EnergyConnect (NSW – Western Section)

Amendment Report

April 2021

Figure 2-4 Proposed Wentworth construction compound and accommodation camp site location

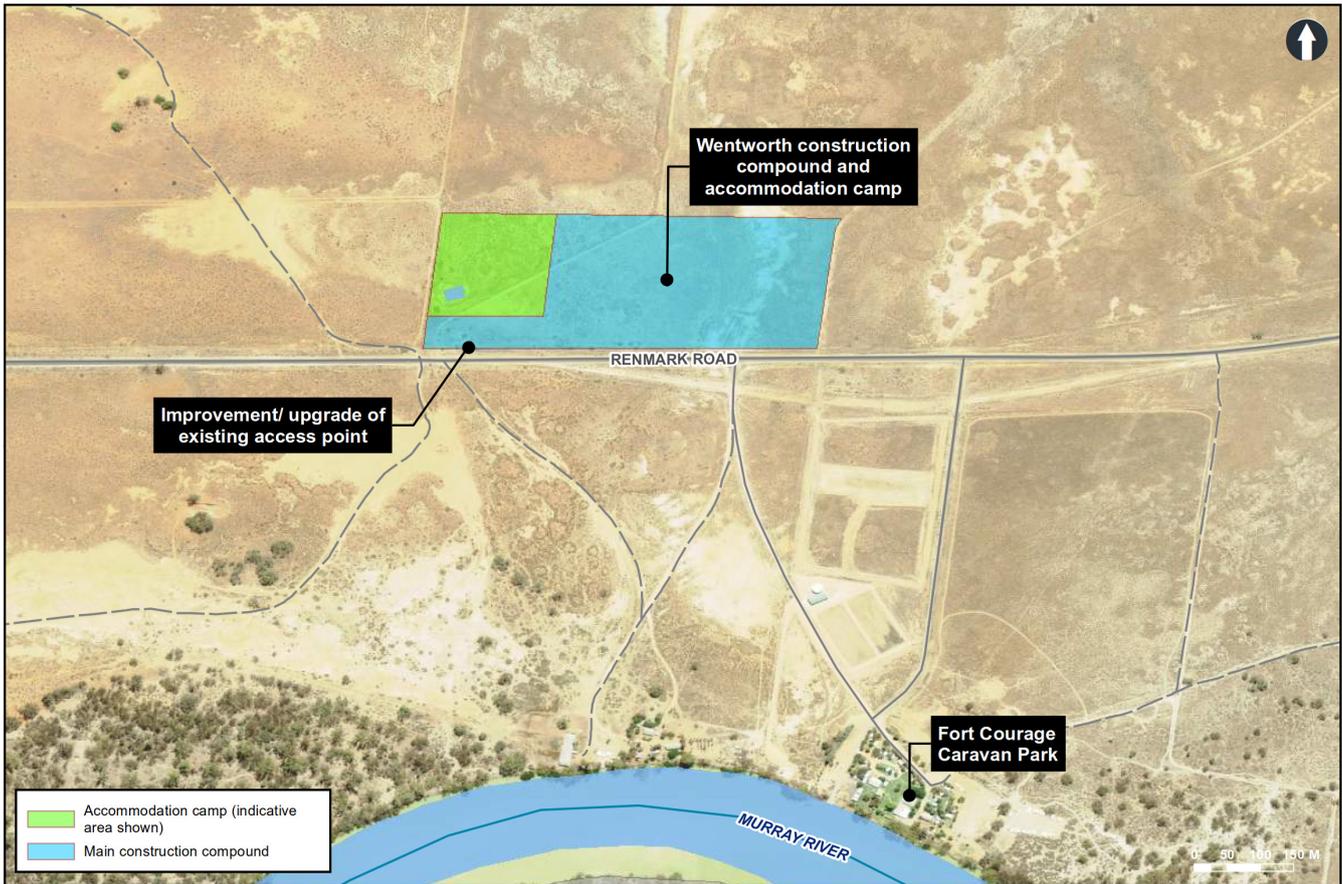
The proposed location for the proposed Wentworth construction compound and accommodation camp site is shown in Figure 2-4. The accommodation camp would house around 200 workers.

Figure 2-5 Revised Anabranch South construction compound site

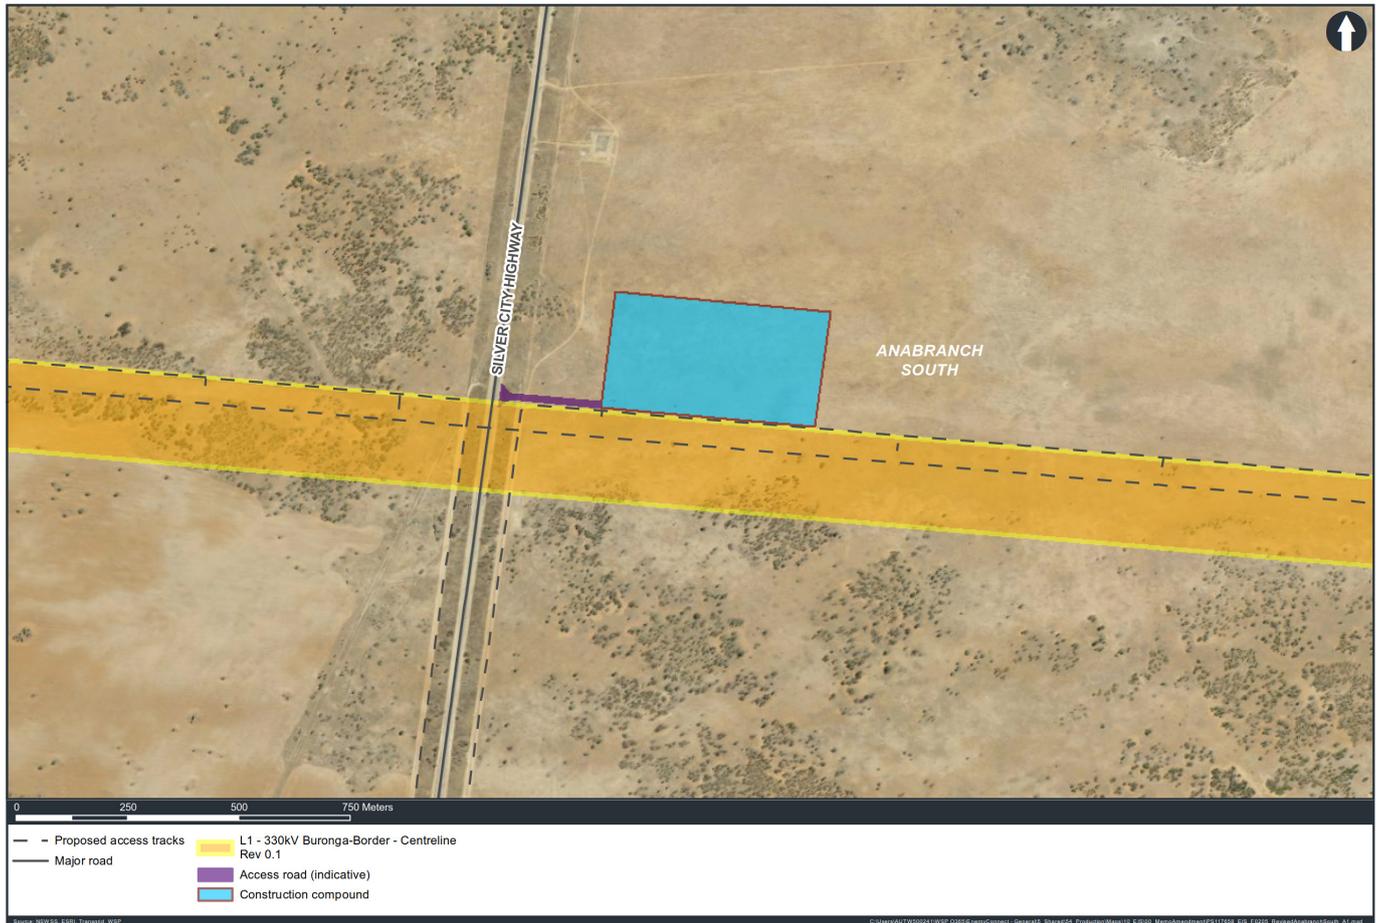
The Anabranch South construction compound site would however be retained as an ancillary construction site to allow for activities such as laydown areas, vehicle and equipment storage, maintenance sheds, potential stockpile areas, and demountable offices and parking (for up to around 10 staff) (refer to Figure 2-5).

The area would be slightly reduced by around 2.5 hectares where the accommodation area is no longer required.

Figure 2-7 Comparison of the proposed substation upgrade and expansion area showing the previous and proposed areas in relation to PAD site PEC-PAD-27

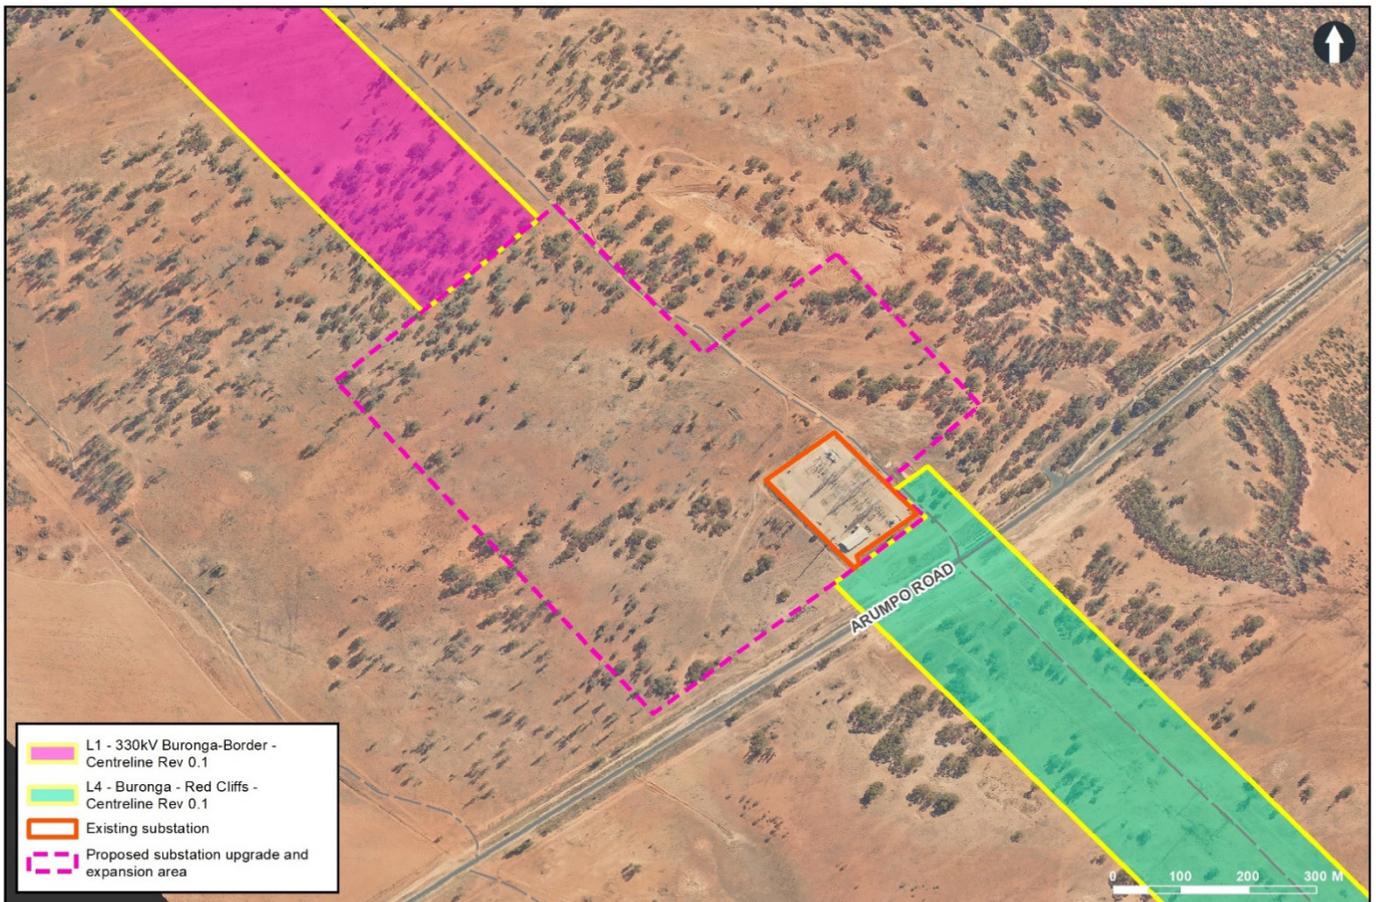
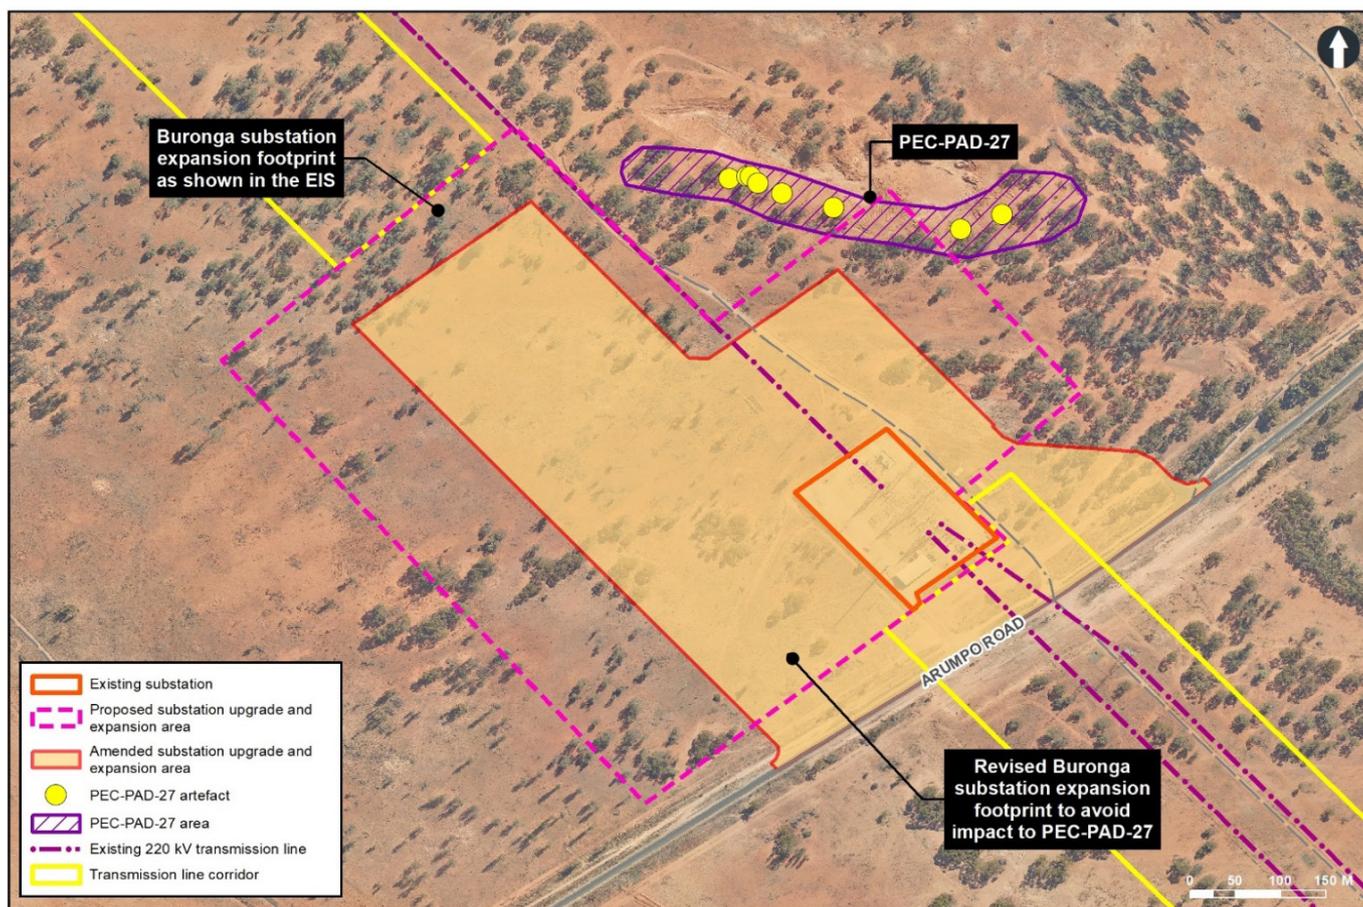
In order to avoid potential impacts to the PEC-PAD-27, the overall footprint for the Buronga upgrade and expansion site has been refined to avoid any direct impacts to the PAD. In addition, the overall substation upgrade and expansion site has been reduced from the area shown in the EIS. The upgrade and expansion would now require a maximum area of around 21.6 hectares (470 metres by 630 metres at its greatest extents).

This would represent an overall decrease in the overall footprint of the proposed substation upgrade and expansion by around 11.9 hectares. A comparison showing the previously proposed and revised substation upgrade and expansion areas is shown in Figure 2-7.

Figure 2-10 Indicative overview showing a section of the proposed 220kV temporary bypass line arrangement

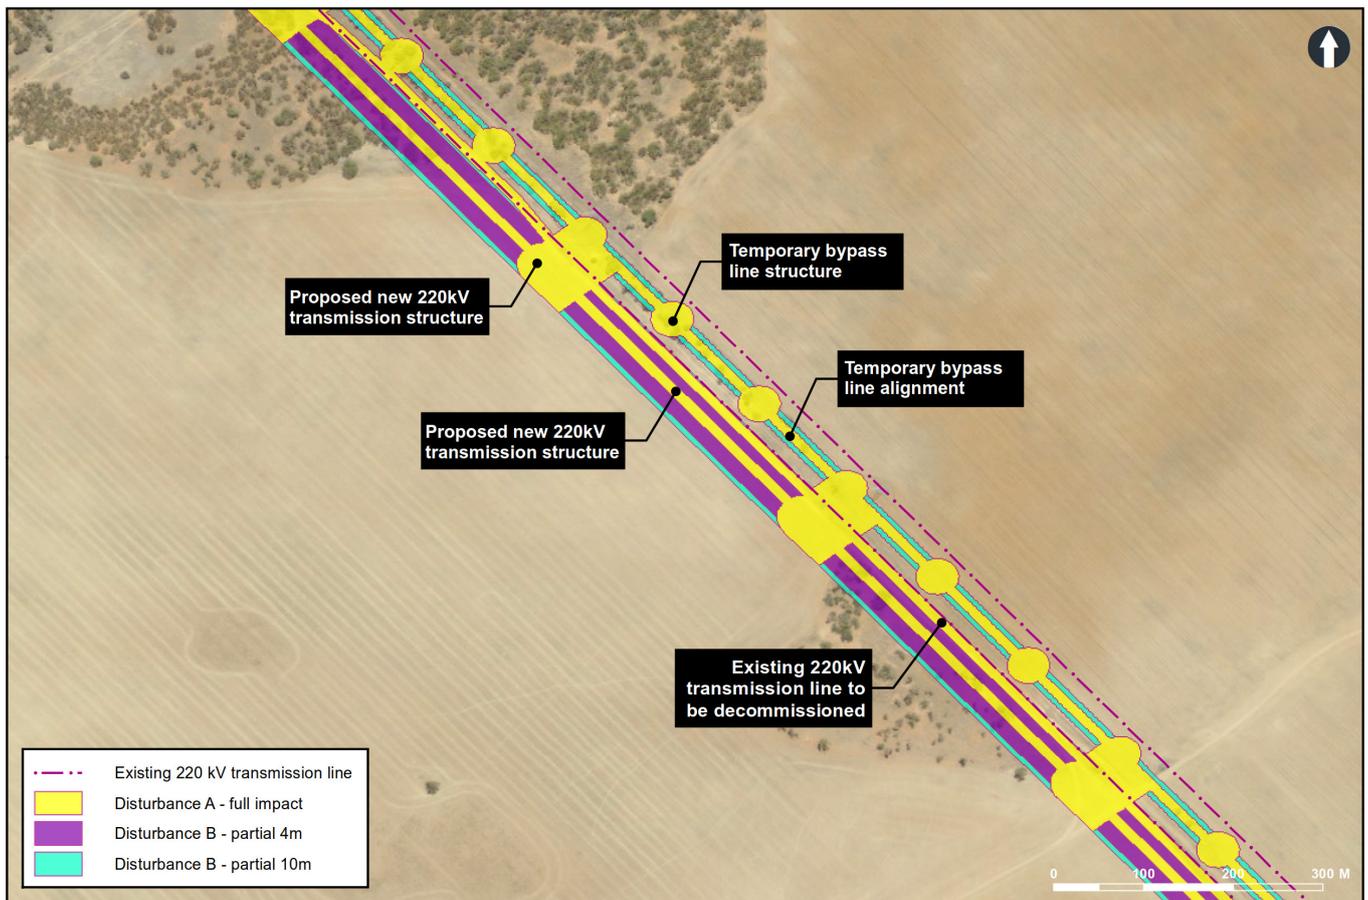
The bypass line would commence from the existing Buronga substation and travel in a south east direction parallel to the eastern side of the existing OX1 220kV transmission line (between the OX1 220kV transmission line and the existing X3 220kV transmission line). The alignment for the proposed bypass line is shown in Figure 2-10.

The bypass line would have an offset of around 25 metres from both the existing 220kV OX1 and X3 transmission lines.

Figure 2-14 Amended indicative disturbance area definition for a typical transmission line section

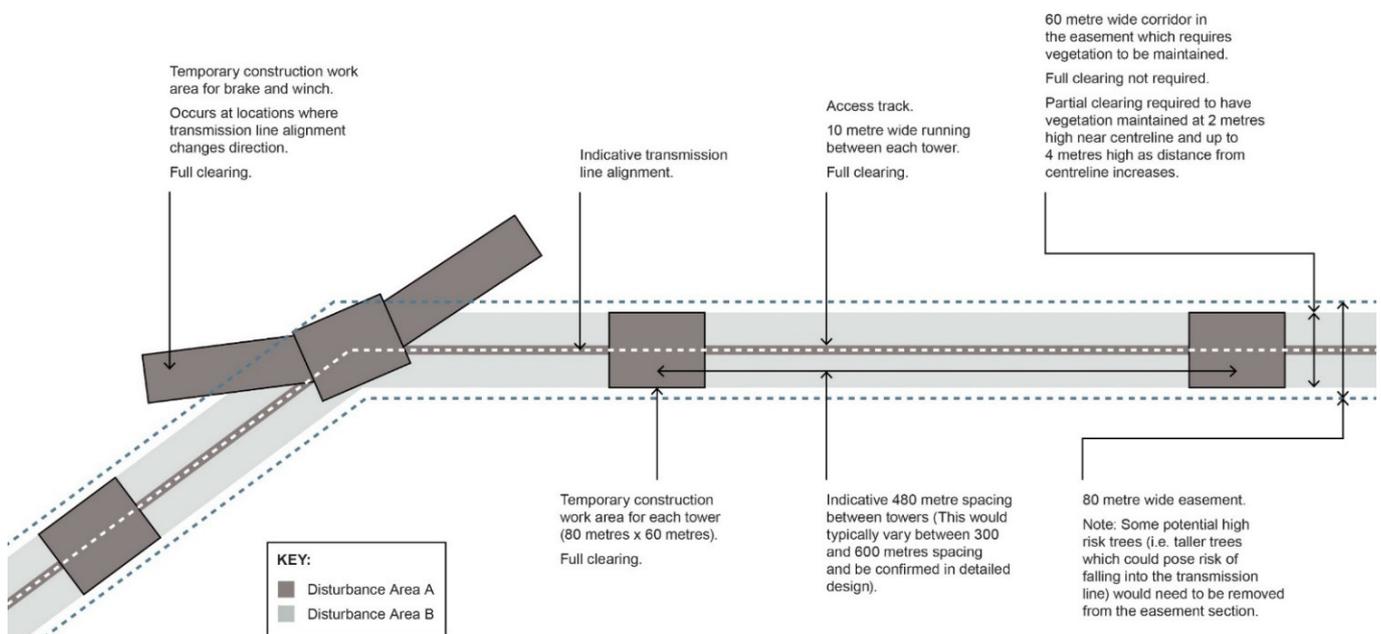
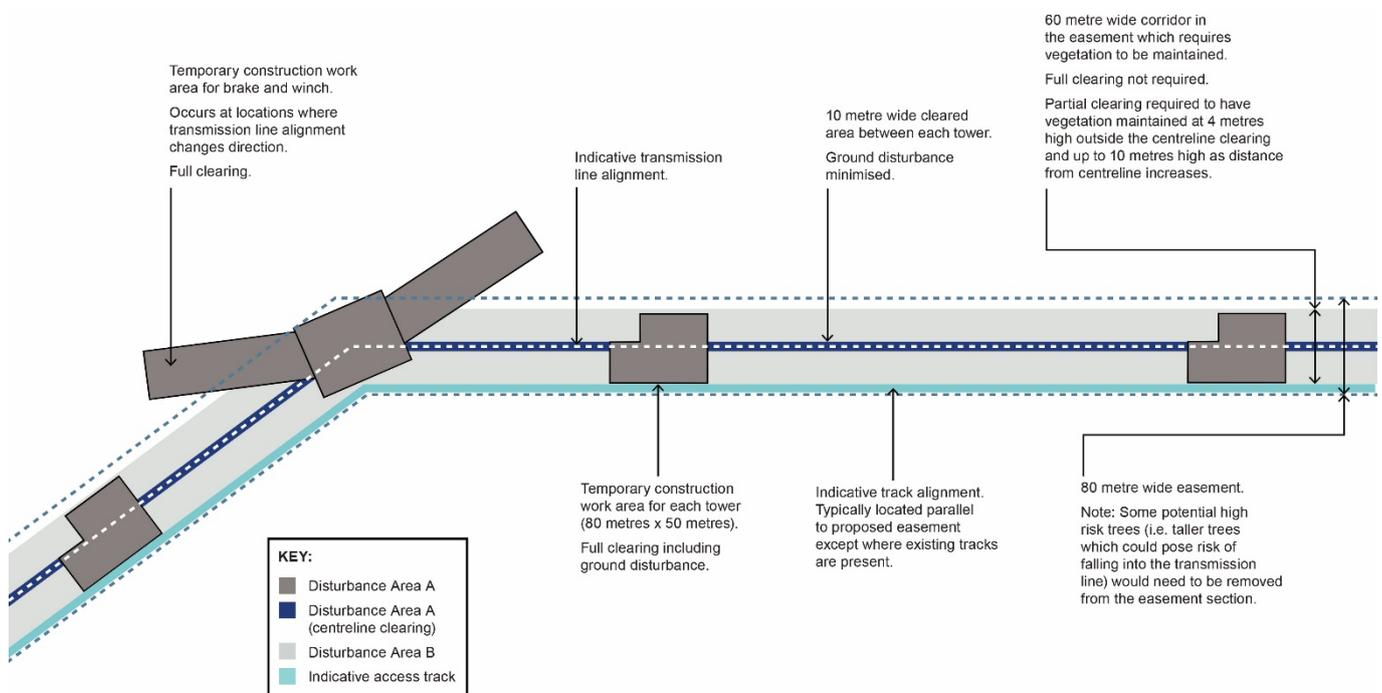
- > **disturbance area B** – this is the area where ground disturbance would not be required except in limited circumstances. It refers to an area between transmission structures in which vegetation growth heights have the potential for infringing on TransGrid’s vegetation clearance requirements. This area has been assessed as including removal of vegetation using a transitional approach scaling from a four metre growth height potential at the middle of the easement, extending to a 10 metre growth height potential or higher at the outer extents of the easement (refer Figure 2-15 for explanation of transitional approach) (noting the EIS provided for clearing of vegetation with a growth height above two metres across the whole of the easement).

An overview of the amended indicative disturbance area is shown in Figure 2-14. A figure showing the indicative approach to vegetation clearing is shown in Figure 2-15 and Figure 2-16. These areas are indicative and may be subject to movement during the detailed design process.

Figure 2-17 Revised alignment to avoid *Austrostipa nullanulla*

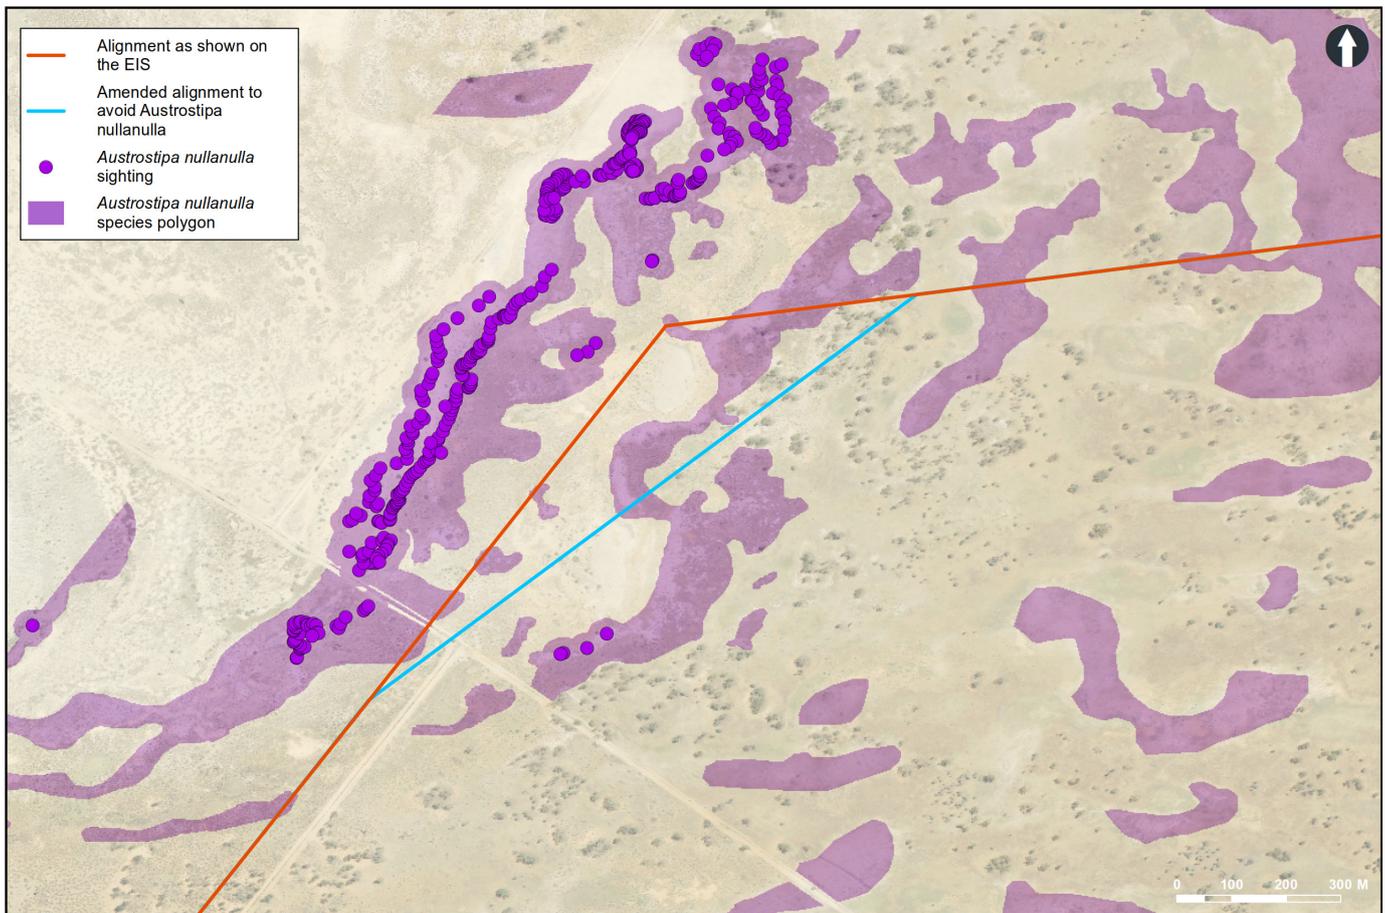
As part of their submission regarding the exhibition of the proposal, the NSW Department of Planning, Industry and Environment – Biodiversity Conservation Division (DPIE BCD) requested an explanation of why this vegetation could not be avoided. To address DPIE BCD submission, further design development of the alignment for the proposal at this location has been undertaken to reduce potential impacts within the vicinity of the *Austrostipa nullanulla*.

Design development has identified an alignment that would enable additional avoidance of this species and its habitat. The amended alignment would provide a deviation of the alignment to the east of the alignment previously proposed. The amended alignment would allow for the relocation of an existing transmission line structure to minimise impacts on recorded *Austrostipa nullanulla*. Refinement of the proposed access tracks has also been undertaken to avoid areas of recorded *Austrostipa nullanulla*. The revised design would still result in some impacts to the *Austrostipa nullanulla* including around 1.15 hectares of habitat (a decrease in impacts by around 0.97 hectares, refer to Section 6.2.2 for details). Ongoing detailed design would seek to further avoid impacts to this species. The revised alignment is shown in Figure 2-17.
